Agency Comments, Comment Responses, and Comment Resolution

Alaska Department of Environmental Conservation
Comments on the Draft Site Characterization and Risk Assessment, Focused Feasibility Study Report, South of Runway 18-36
FORMER NAVAL AIR FACILITY, ADAK
February 2005

Alaska Department of Environmental Conservation
Comments on the Revised Draft Focused Feasibility Study Report for South of Runway 18-36 Area
FORMER NAVAL AIR FACILITY, ADAK
July 2005

**Plate 1
DRO, GRO, and BTEX Concentrations in Soil
South of Runway 18-36 Area**

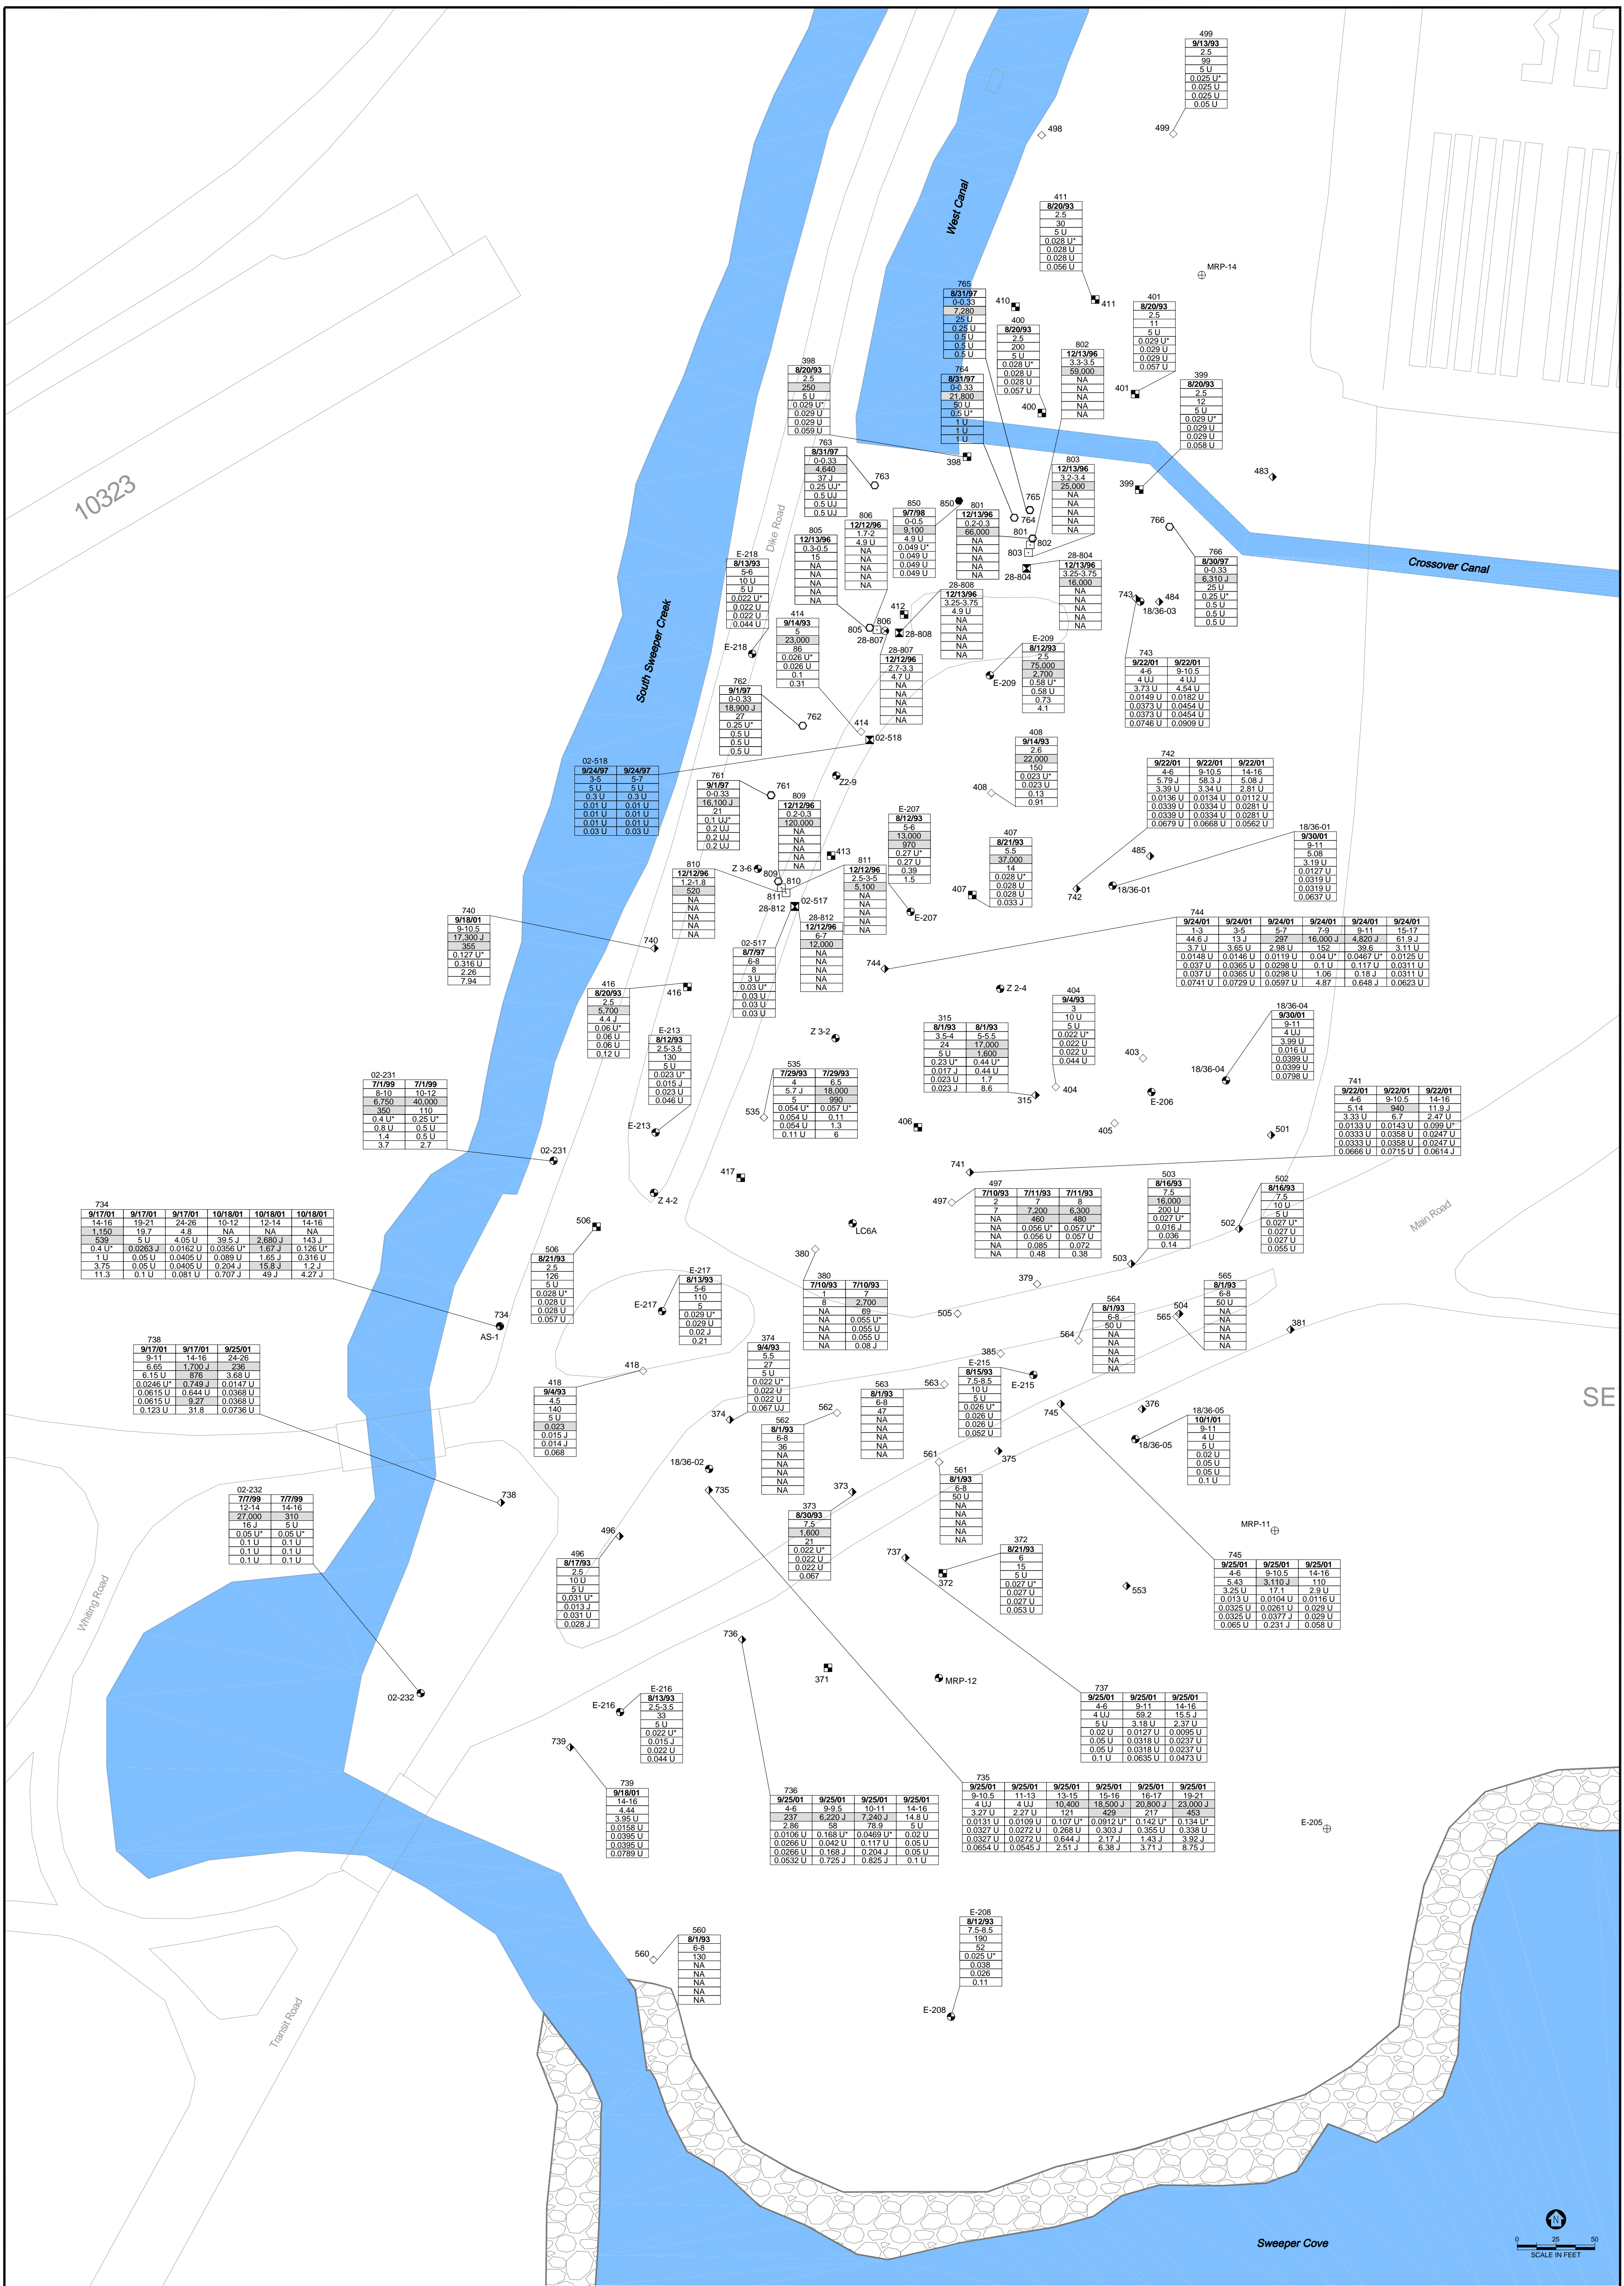
9	3-14 Line 28-33	3.5.3	This paragraph discusses prior remedial actions and the use and disposition of sediment samples in the remedy development and evaluation process. The highlighted sentences discuss that sediment is now considered soil because it has been covered in place. However, these sampling locations are not represented in the soils data	Locations 761, 762, 763, 764, 765, 766, 801, 805, and 809 will be added to Figure 3-3 and Plate 1 and designated as buried sediments. Results of analyses for GRO, DRO, and BTEX compounds in sediment samples collected from these 9 locations will be added to Plate 1.

Cmt. No.	Pg. & Line	Sec.	Comment/Recommendation	Response
			on Figure 3-3 or on Plate 1. We request the addition of these samples to the figures along with a specific symbol identifying them as buried sediments.	
10	3-15 Lines 5-8	3.5.3	This paragraph discusses the volume of remaining contaminated sediments in Sweeper Creek. Figure 3-5 illustrates where sediments were removed in 1999. Please add a new figure or append Figure 3-5 to show the location of the remaining petroleum contaminated sediments discussed in this section.	Figure 3-5 will be modified to show the area in South Sweeper Creek estimated to contain contaminated sediments. In addition, the subject paragraph will be replaced with the following: The volume of petroleum contaminated sediments remaining in South Sweeper Creek is estimated to be approximately 6,400 cubic yards. This volume is based on an estimated area of contaminated sediments within the creek of 86,900 square feet, shown on Figure 3-5, and a presumed thickness of two feet. Because sediment moves dynamically through this section of South Sweeper Creek, and because petroleum hydrocarbons continue to enter the creek from the South of Runway Area site, the area estimated to contain petroleum-affected sediments includes portions of the creek where sediment was removed during 1999.

Plate 2
DRO, GRO, and BTEX
Concentrations in Groundwater
South of Runway 18-36 Area

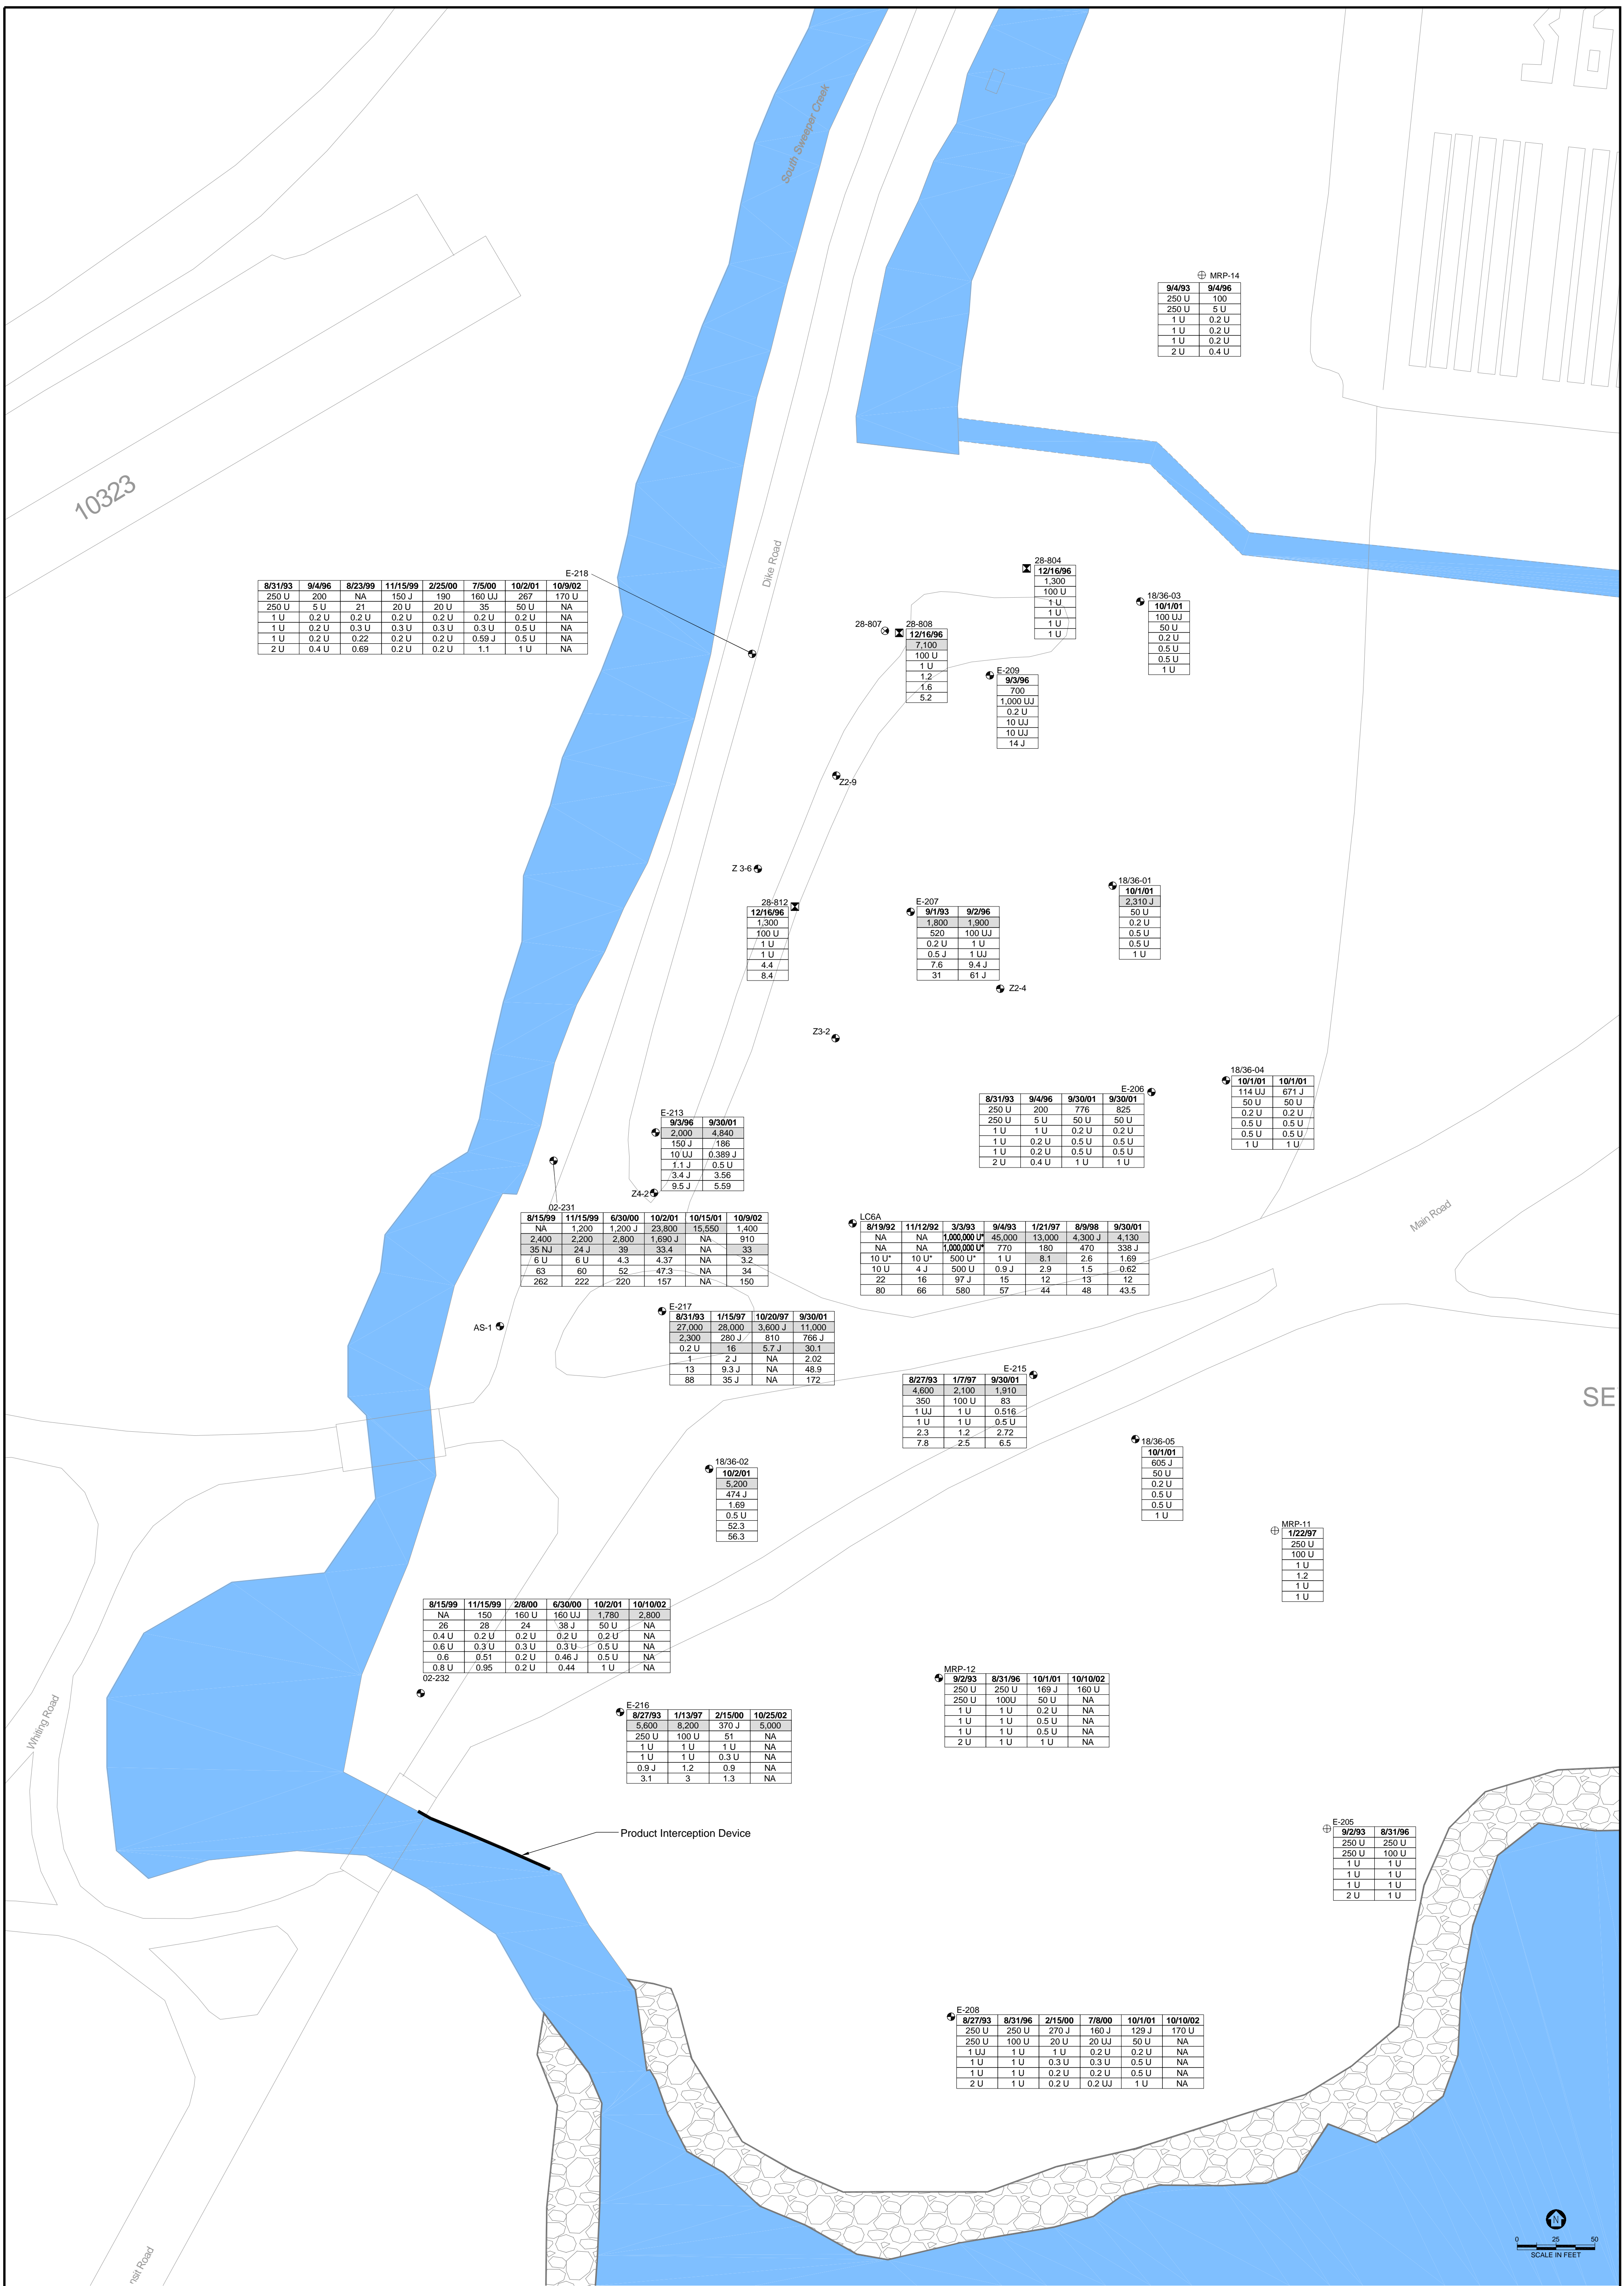
7	3-4 Line 30	3.3.2	The moving averages are shown on Figure 3-1, not Figure 3-3. Please revise.	The sentence will be changed to refer to Figure 3-1 not Figure 3-3.
8	3-11 and 3-12	3.5.1 and 3.5.2	The two sections listed reference Plates 1 and 2. We recommend adding wording after the initial introduction of the plates to tell the reader where to find them (located in the back of the document.)	The last sentence in the first paragraph in Section 3.5.1 will be replaced with the following: Results of chemical analyses for DRO, GRO, and BTEX in soil at each of the sampling locations for the South of Runway Area are shown on Plate 1, included at the end of this document. The last sentence in the first paragraph in Section 3.5.2 will be replaced with the following: Results of chemical analyses for DRO, GRO, and BTEX in groundwater at each of the sampling locations for the South of Runway Area are shown on Plate 2, included at the end of this document.
